RE: Range/Soo San Signal Issue

# Traffic Analysis Report

## Traffic Control Signal Needs

March 2, 2005

# Warrant 2, Four-Hour Vehicular Volume

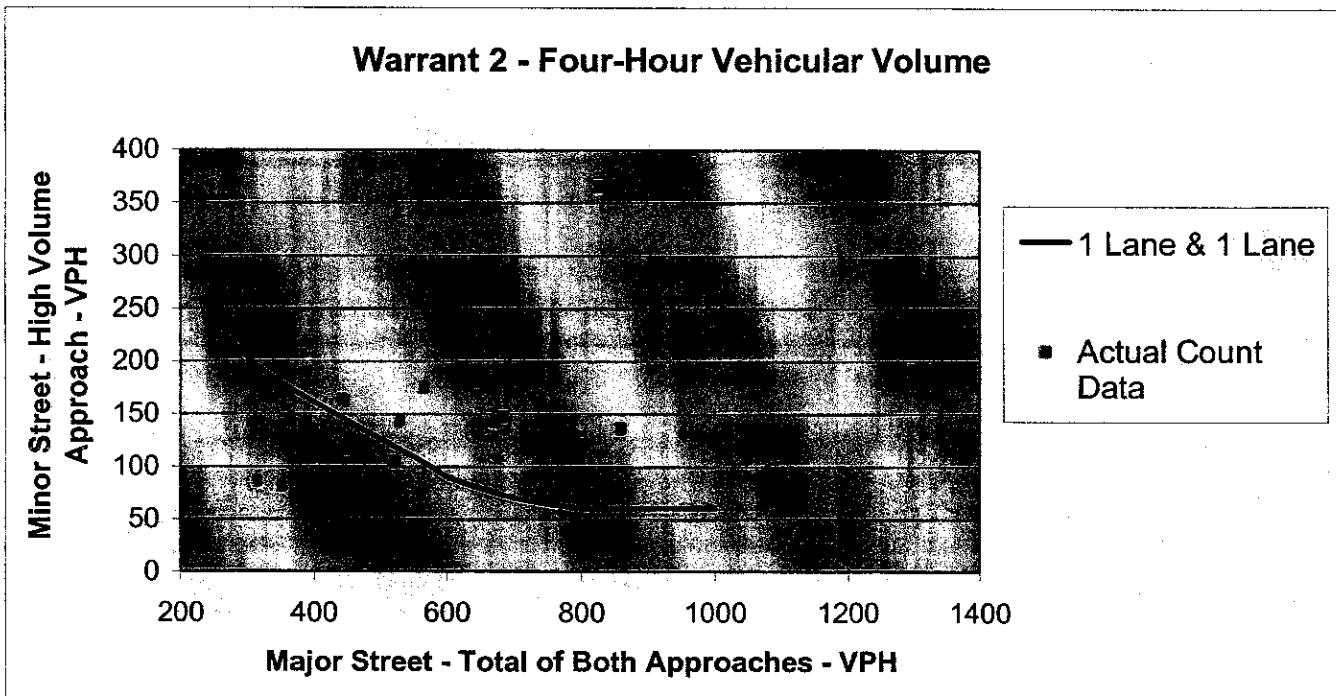
If 4 or more red dots fall above the blue line then this intersection complies with this warrant.

This intersection meets the minimum criteria set forth for this warrant.

# Warrant 3, Peak Hour

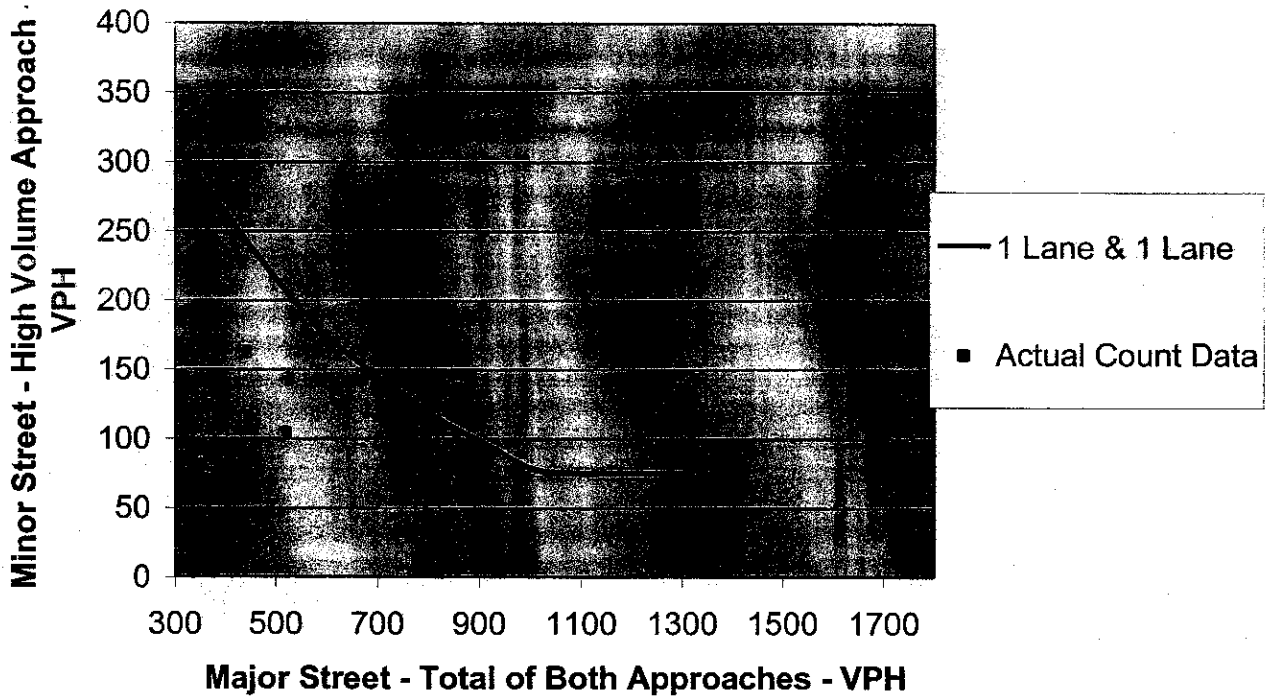
This intersection does not comply with Part A of this warrant.

If 1 or more red dots fall above the blue line then this intersection complies with Part B of this warrant.

This intersection does comply with Part B of this warrant.

This location does not comply with this warrant.
